City of TIFFIN

DATE:	August 27, 2026
AGENDA ITEM:	Approval of Change Order #3 – Tricon Construction Group – Water Treatment Facility Upgrade
ACTION:	Motion

CHANGE ORDER NO.: 3

Owner:	City of Tiffin	Owner's Project No.:	
Engineer:	MSA Professional Services	Engineer's Project No.:	13603021
Contractor:	Tricon Construction Group	Contractor's Project No.:	25-012-IA
Project:	Tiffin WTF Upgrade		
Contract Name:	13603021 – Tiffin WTF Upgrade		
Date Issued:	August 19, 2026	Effective Date of Change Order:	September 1, 2026

RO BUILDING

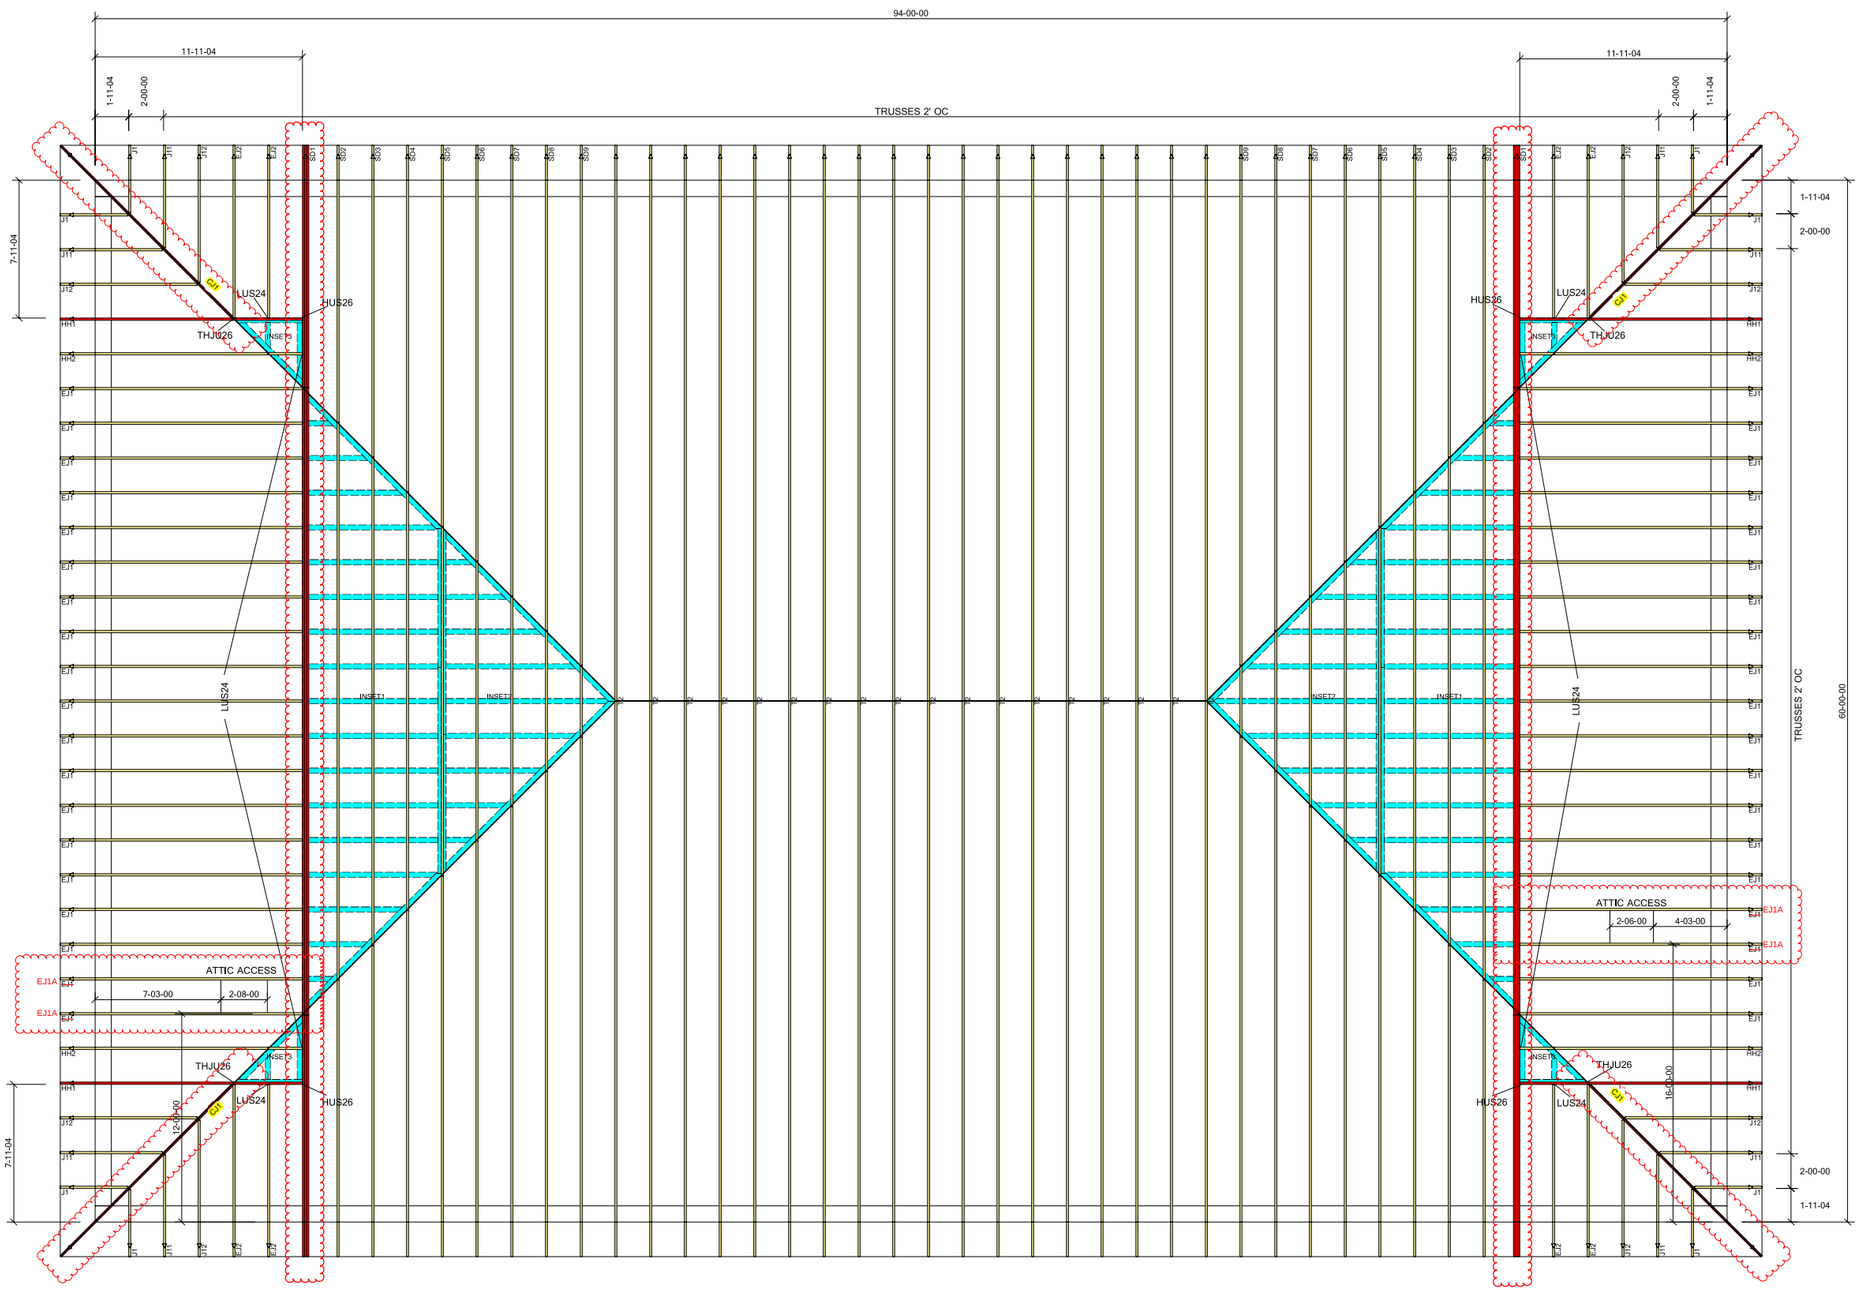
Required truss modifications due to code changes indicated here

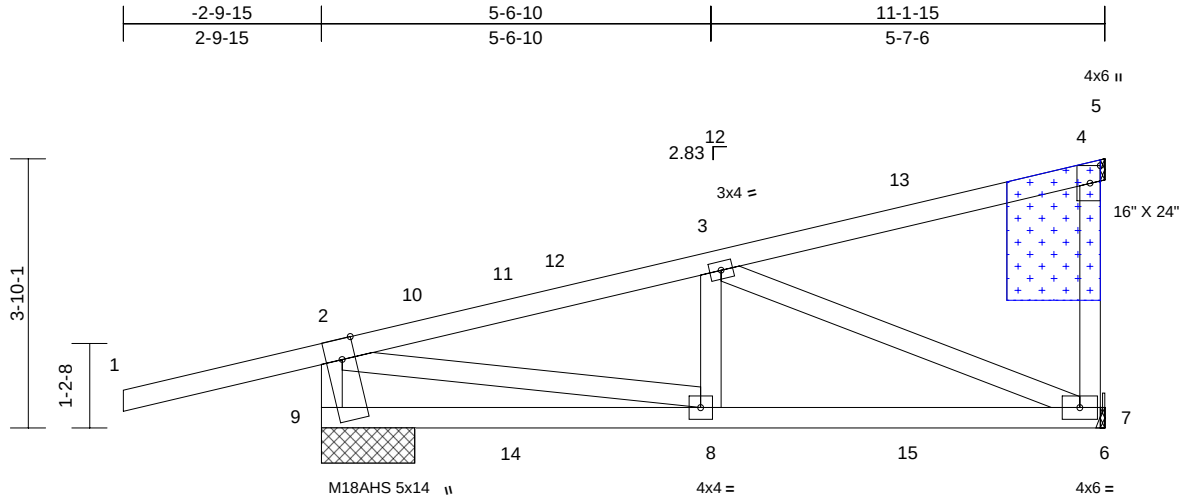
REPAIR:
BUILDING CODE CHANGED FROM 2015 TO 2018

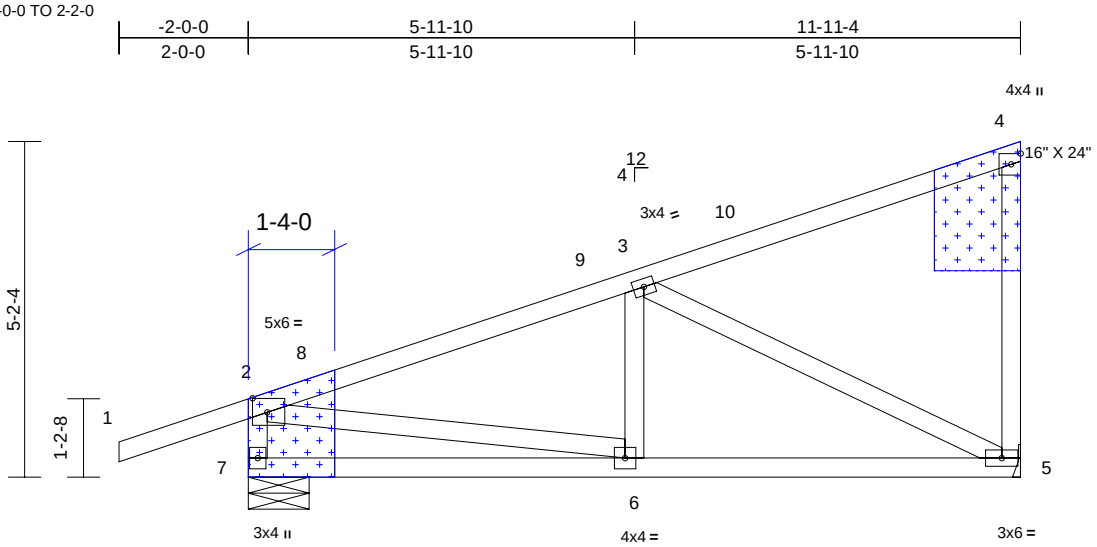
REPAIR:
BUILDING CODE CHANGED FROM 2015 TO 2018
SPACING CHANGED FROM 2-0-0 TO 2-2-0

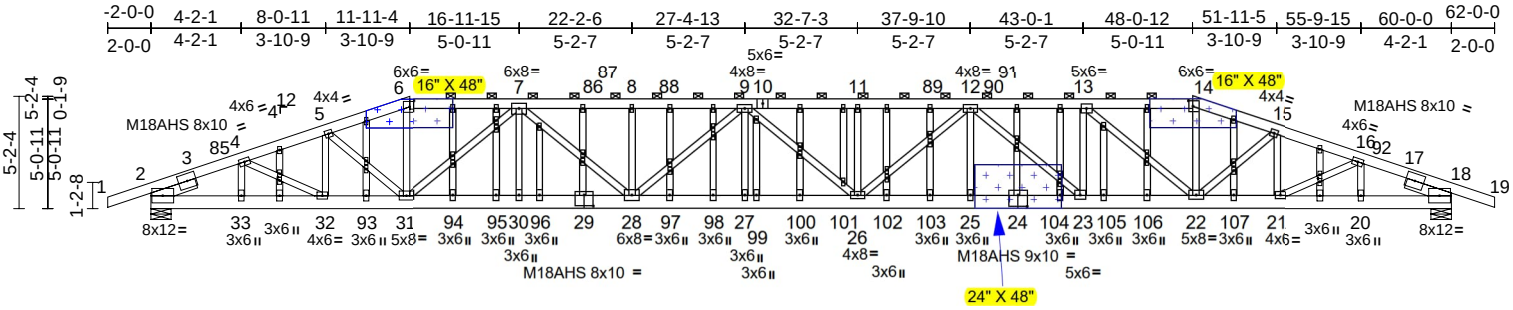
REPAIR:
BUILDING CODE CHANGED FROM 2015 TO 2018

ATTACH 3/4" PLYWOOD OR OSB GUSSET (23/32" RATED SHEATHING 48/24 EXP 1) TO EACH FACE OF TRUSS WITH (0.131" X 2.5" MIN.) NAILS PER THE FOLLOWING NAIL SCHEDULE: 2 X 4'S - 3 ROWS, 2 X 6'S AND LARGER - 4 ROWS: SPACED @ 4" O.C. NAILS TO BE DRIVEN FROM BOTH FACES. STAGGER SPACING FROM FRONT TO BACK FACE FOR A NET 2" O.C. SPACING IN EACH COVERED TRUSS MEMBER. USE 2" MEMBER END DISTANCE.

MCC Room Trusses

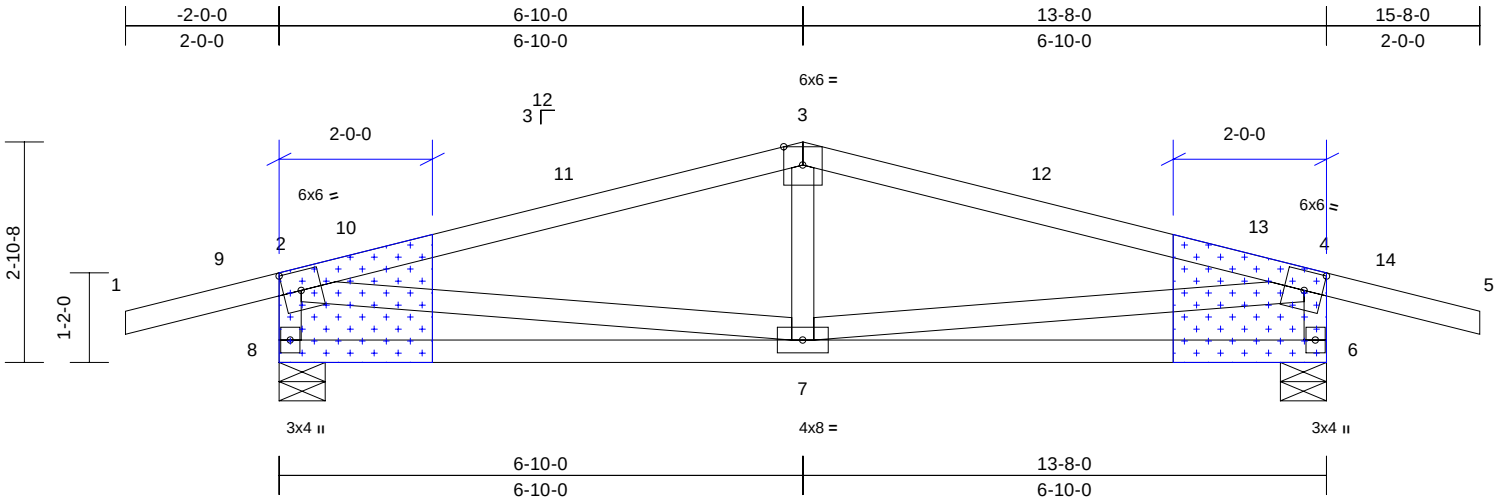
REPAIR:
BUILDING CODE CHANGED FROM 2015 TO 2018

ATTACH 1/2" PLYWOOD OR OSB GUSSET (15/32" RATED SHEATHING 32/16 EXP 1) TO EACH FACE OF TRUSS WITH (0.131" X 2.5" MIN.) NAILS PER THE FOLLOWING NAIL SCHEDULE: 2 X 4'S - 3 ROWS: SPACED @ 4" O.C. NAILS TO BE DRIVEN FROM BOTH FACES. STAGGER SPACING FROM FRONT TO BACK FACE FOR A NET 2" O.C. SPACING IN EACH COVERED TRUSS MEMBER. USE 2" MEMBER END DISTANCE.
